Access Compliance Report

Public Rights-of-Way

(Curb Ramps)

Intersection ID: 24356	Main Street: BEVERLY_CREST_BV	Cross Street: CAMAROSS_DR	Location: W
ADA ID: E008EB6B6EFF	Ramp Type: Perp	Initial Pass/Fail: Fail	Overall Compliance: No
			Severity Score: 8.75
Codes/Mitigation Info/Possible Solution		Field Measurements/Component Compliance

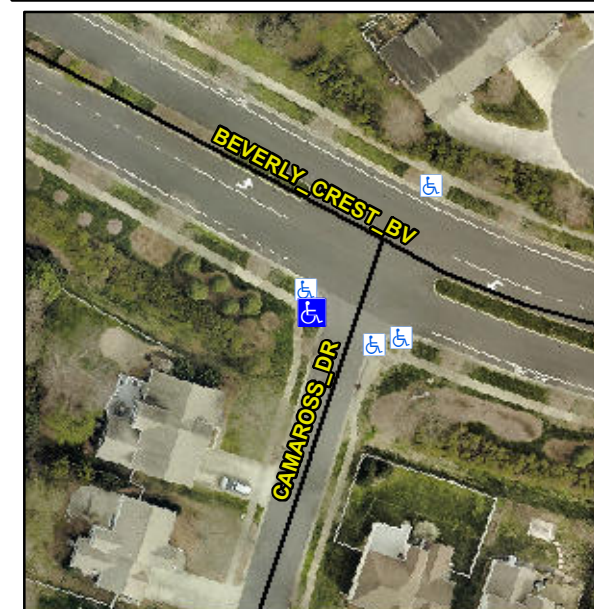
Not Found, R304.5.1

Compliance	Description	Data	Compliance	Description	Data
N/A	Ramp Length (in)	96.0	Yes	Ramp Slope (%)	7.9
No	Ramp Width (in)	45.0	Yes	Ramp XSlope (%)	0.4
N/A	Flare Type LT	N/A	N/A	Flare Type RT	N/A
N/A	Flare Slope LT (%)	N/A	N/A	Flare Slope RT (%)	N/A
N/A	Flare Traversable LT?	N/A	N/A	Flare Traversable RT?	N/A
N/A	Landing Length (in)	N/A	N/A	DWS Provided?	N/A
N/A	Landing Width (in)	N/A	N/A	DWS Contrast?	N/A
N/A	Landing Slope (%)	N/A	N/A	DWS Length (in)	N/A
N/A	Landing X Slope (%)	N/A	N/A	DWS Full Width?	N/A
N/A	Landing Curb? (Y/N)	N/A	N/A	DWS Offset (in)	N/A
N/A	Shared Landing?	N/A			
N/A	Gutter Ponding?	N/A	N/A	Gutter Slope (%)	N/A
N/A	Gutter Lip Ht (in)	N/A	N/A	Gutter X Slope (%)	N/A
N/A	Painted X Walk1?	No	N/A	Painted X Walk2?	N/A
	X Walk 1 Direction	To SE		X Walk 2 Direction	N/A
N/A	X Walk 1 Width (in)	N/A	N/A	X Walk 2 Width (in)	N/A
	X Walk 1 Slope (%)	3.9		X Walk 2 Slope (%)	N/A
	X Walk 1 X Slope (%)	1.9		X Walk 2 X Slope (%)	N/A

Remove & Replace Entire Ramp.
